## D/DRC Case

2225 Wayne Street

**DESIGN/DEVELOPMENT REVIEW COMMISSION**  
**DESIGN REVIEW DISTRICT**  
**HISTORIC AGENDA**  
**EVALUATION SHEET**  
Case #13

**NATURE OF REQUEST:** Request for a Certificate of Design Approval for new construction

**SITE PLAN**  
 SCALE: 1"=20'

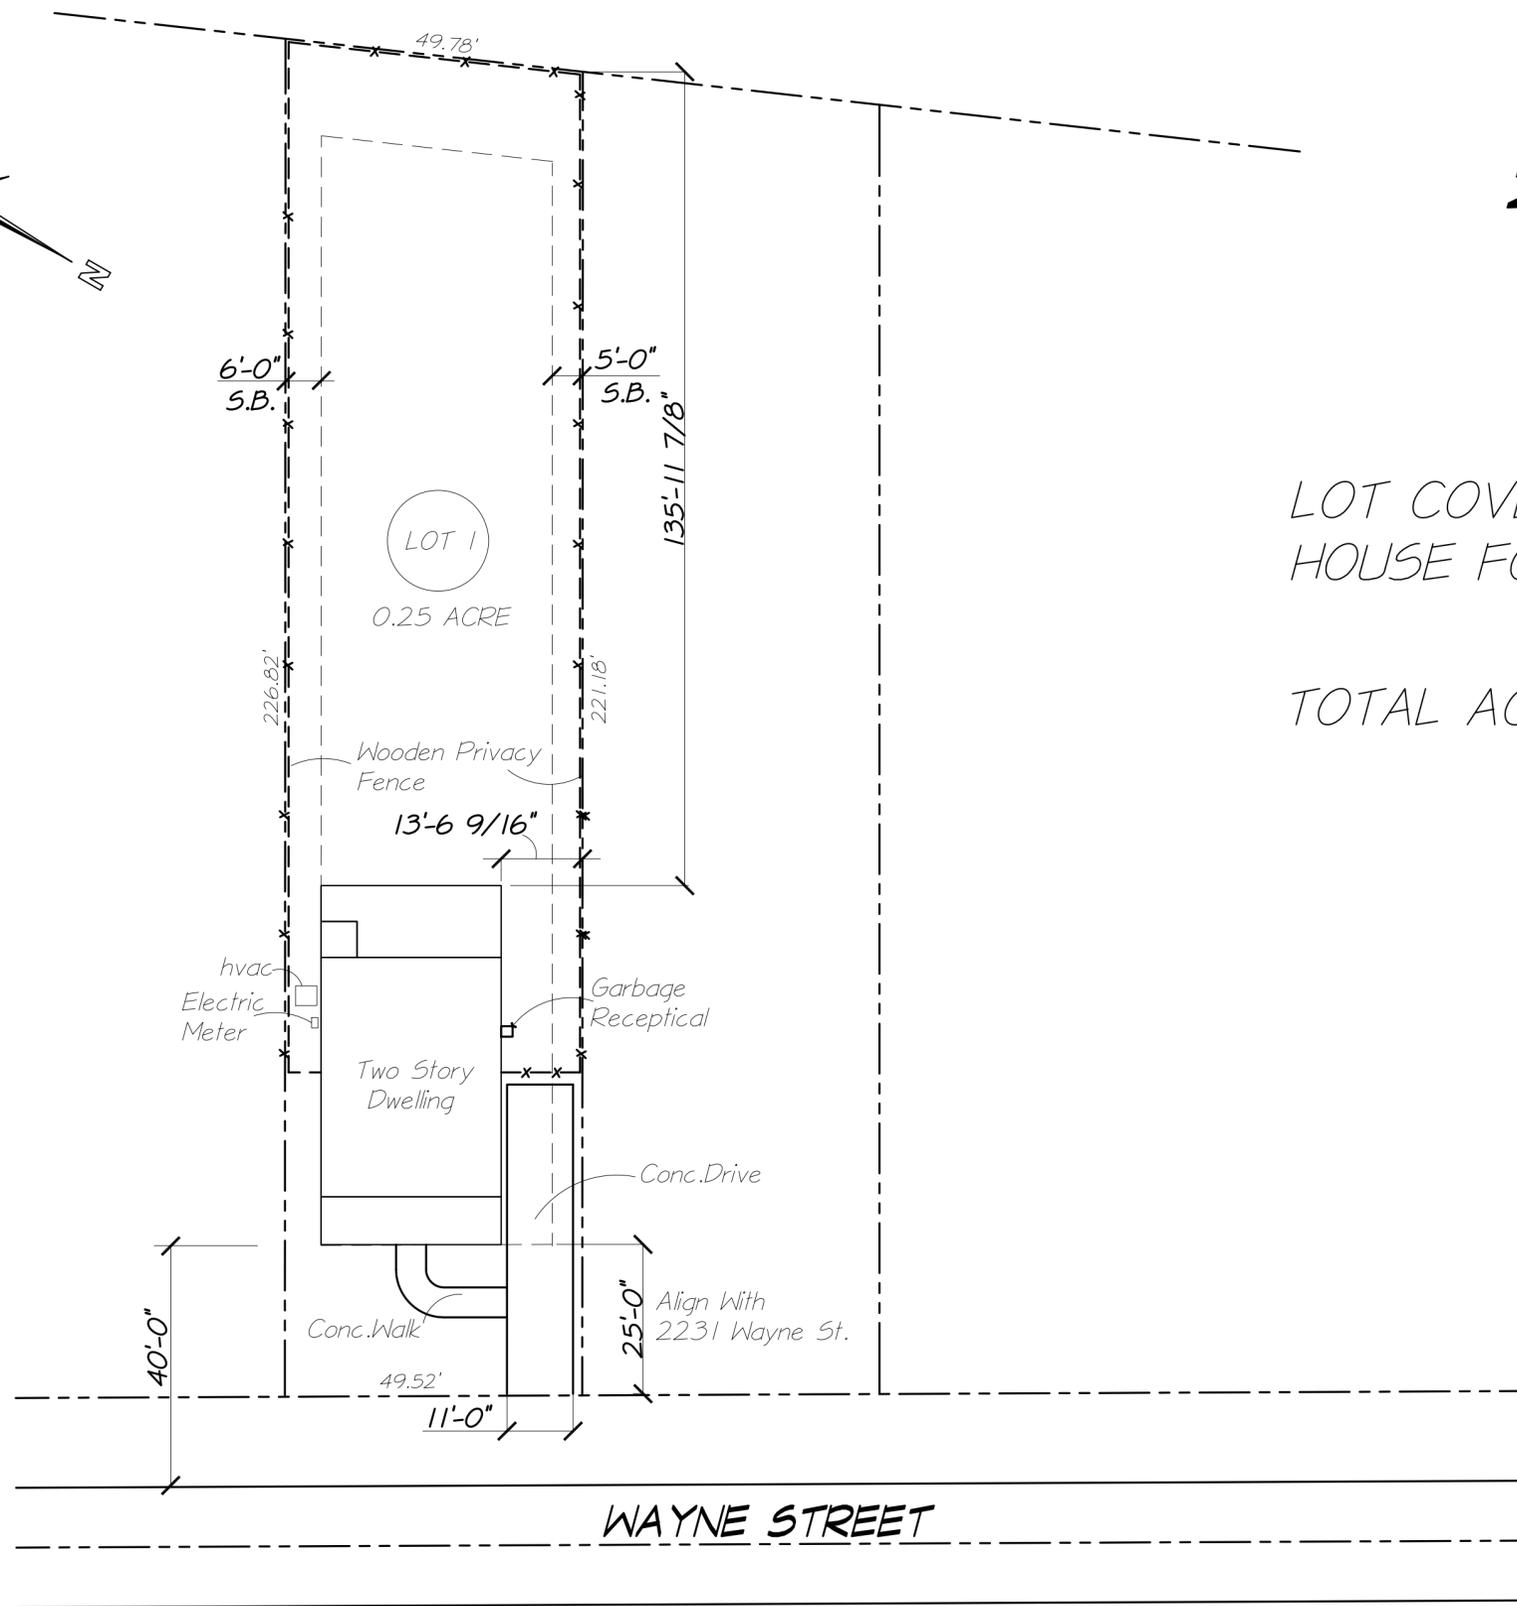
The PUD was originally written and approved with front yard setbacks reduced to 10 feet. Staff recommends making the new house flush with 2231 Wayne Street, which was approved by the D/DRC with a 25' setback.

The location of a proposed wooden privacy fence is shown on the site plan. Staff will work out any fence and gate details with the applicant if required as fences and walls can be reviewed by staff.

The concrete driveway will extend from the curb cut to just over midway of the right side of the house. While the driveway is indicated at 11 feet on the site plan, it is

allowed a maximum total width of 12 feet per City ordinance. A concrete walkway will connect the driveway to the front steps.
